No.	Date	Description
1	2025-09-19	Add No. 1
2	2025-09-30	Add No. 2

**WCFPD Station 3**  
**Wright City Fire Protection District**  
9 Highway WW  
Wright City, MO 63390

4 WALL SECTION 4/A321  
A321 3/4" = 1'-0"

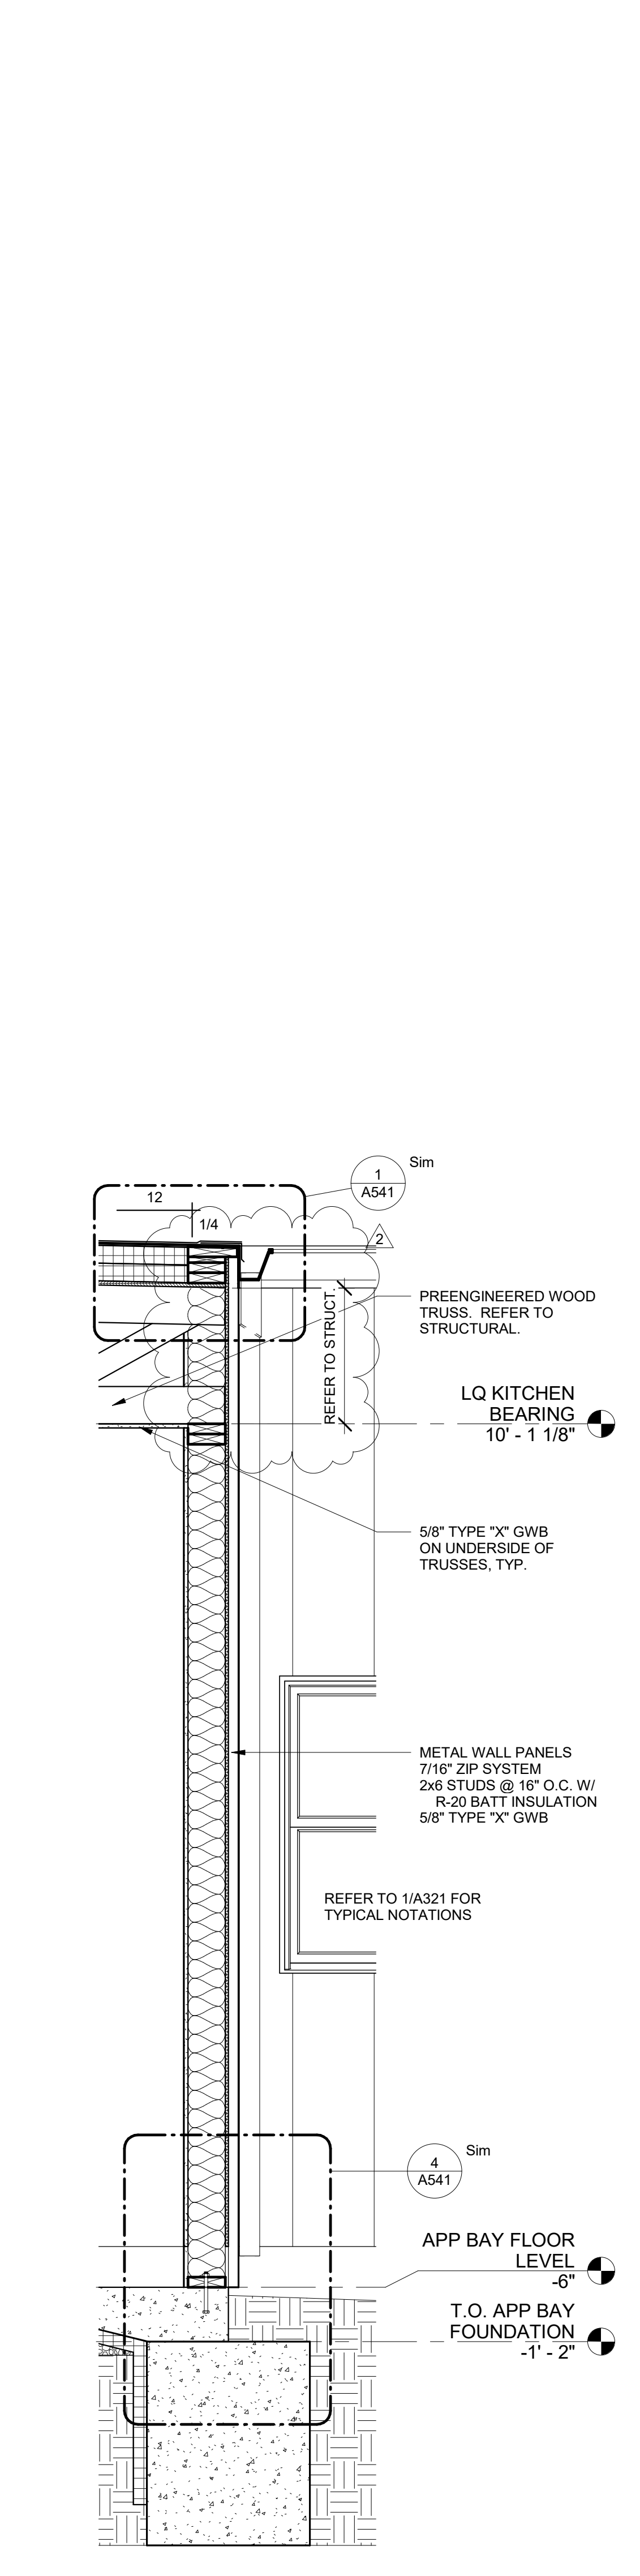
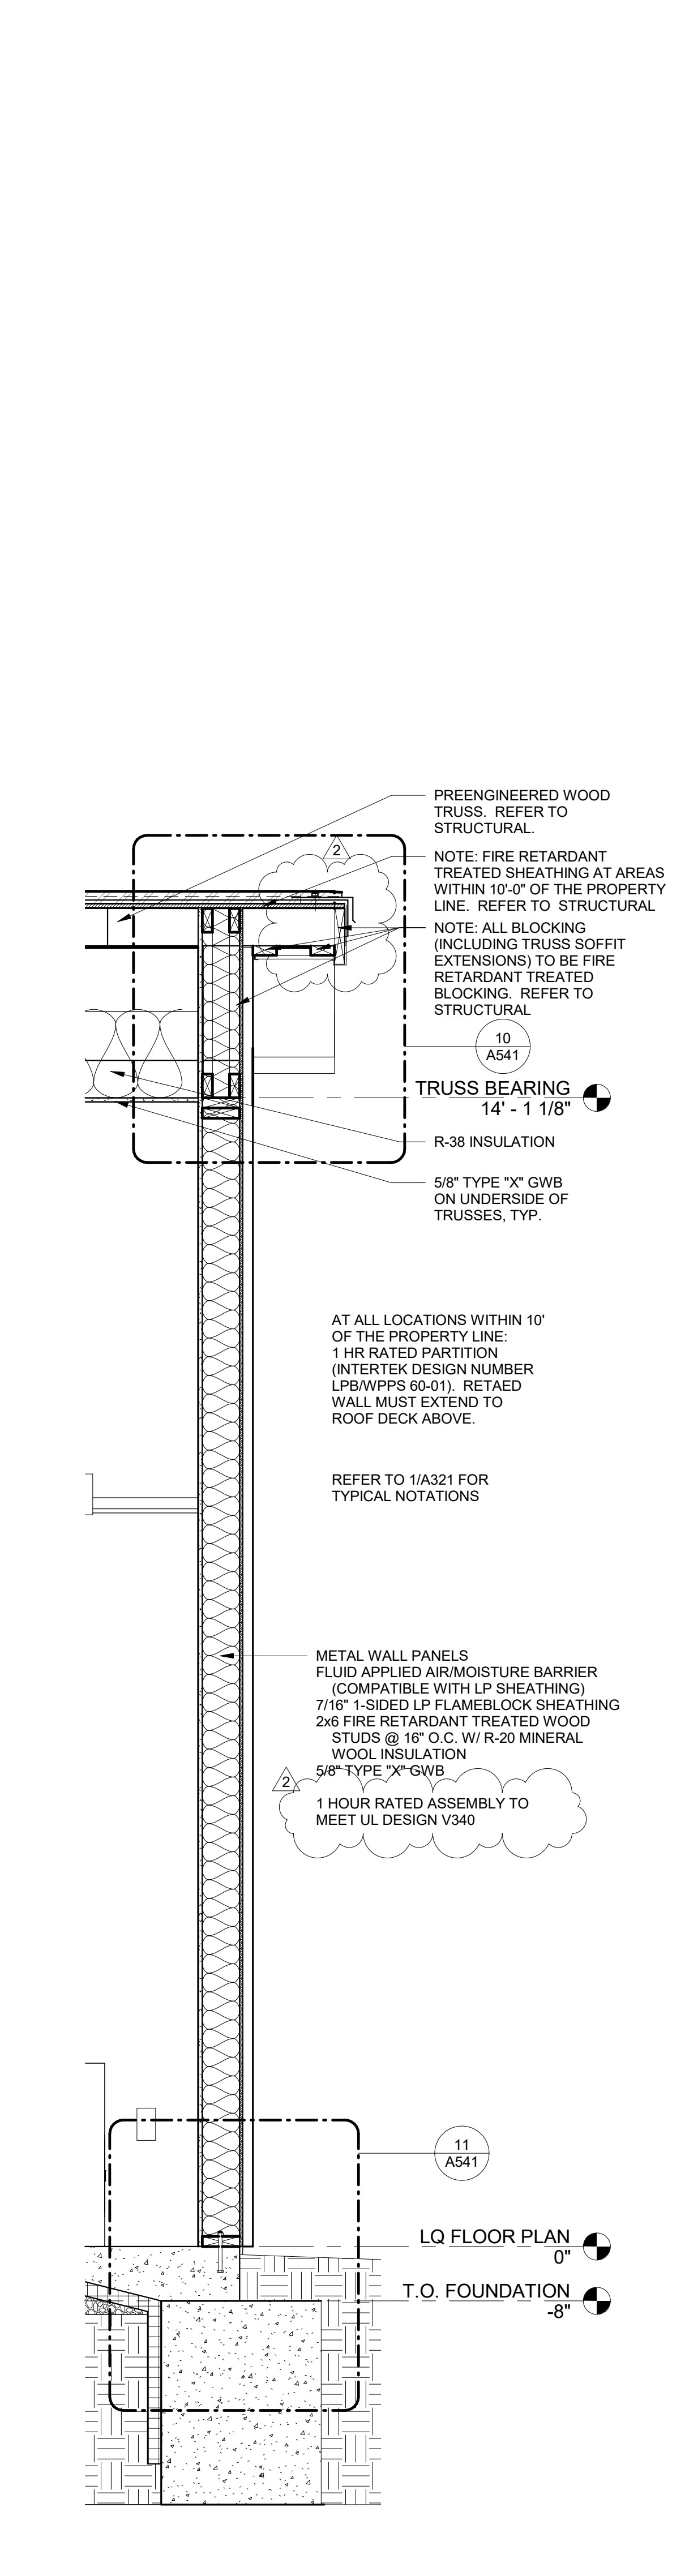
- 23) Sheet A321 – WALL SECTIONS
  - a. REVISE all wall sections.
  - b. ADD fireblocking note.
- 24) Sheet A322 – WALL SECTIONS
  - a. REVISE wall sections.
